ELECTRIC INSTALLATION

4681 W. 46TH AVE., DENVER, CO.

2025-UTIL-0000276

ELECTRIC INSTALLATION
4681 W. 46TH AVE.
DENVER, CO.
CCD COMMENT REPORT

UTILITY PLAN

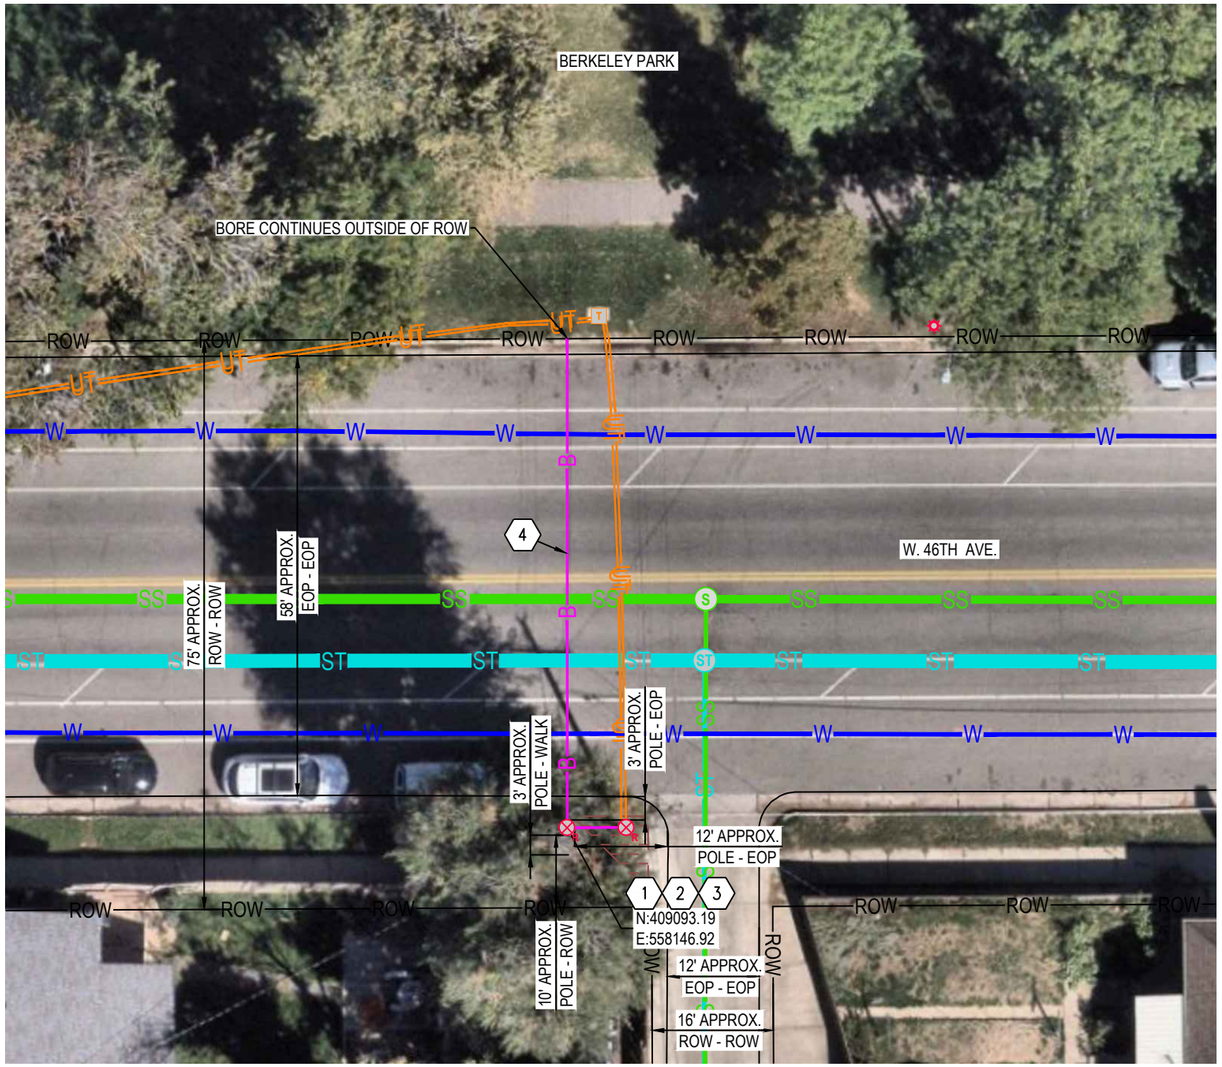
Status Date: 12/30/2025
Status: Denied
Comments: 1. Pole is located within the pedestrian sight triangle. Please remove or relocate proposed pole.
